Reference: 1. USNRC Docket No. 71-9261 (HI-STAR 100), TAC No. L23796
2. Holtec Project 5014
3. SFPO Letter dated 23 April 2004

Subject: Request for Additional Information for HI-STAR 100 Transportation Package

TRANSPORT CoC AMENDMENT REQUEST #3, REVISION 1

TRANSMITTAL LETTER + SEVEN ATTACHMENTS

FIGURE 5.3.9; HI-STAR 100 OVERPACK CROSS SECTIONAL VIEW SHOWING THE THICKNESS OF THE MPC SHELL AND OVERPACK AS MODELED IN MCNP. THE MPC-24 IS SHOWN FOR ILLUSTRATIVE PURPOSES ONLY.

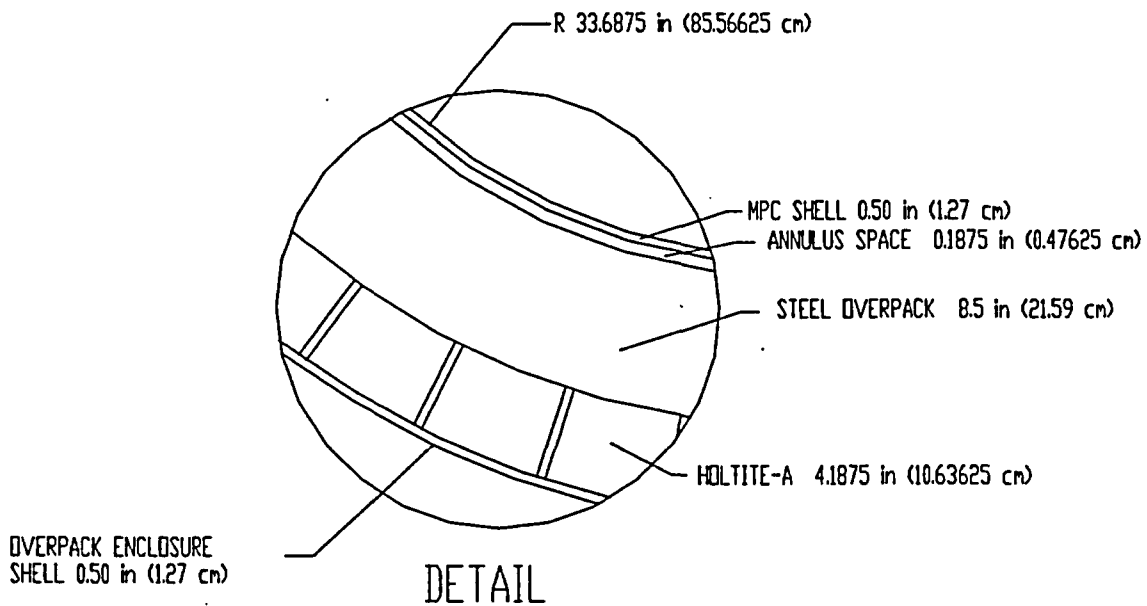
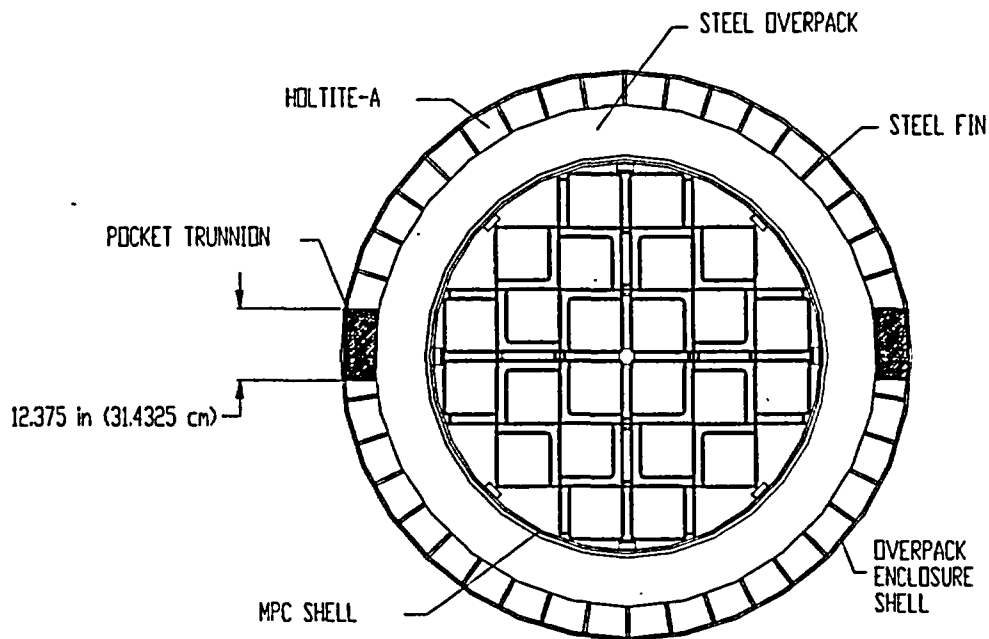
- 5-3 Figure 5.3.9 displays a detailed cross sectional view of the HI-STAR 100 overpack with the MPC-24 (showing the thickness of the MPC shell and overpack as modeled in MCNP). Provide a similarly detailed view of the HI-STAR 100 with the MPC-32 on Figure 5.3.1.

Figure 5.3.9 provides the detail of the HI-STAR 100 overpack as it was modeled in MCNP. The dimensions shown in the figure were used for all MPCs (MPC-24, MPC-32, and MPC-68). The MPC-24 is only shown as a representative basket. The figure caption has been modified to state that the MPC-24 is shown only for illustrative purposes only.
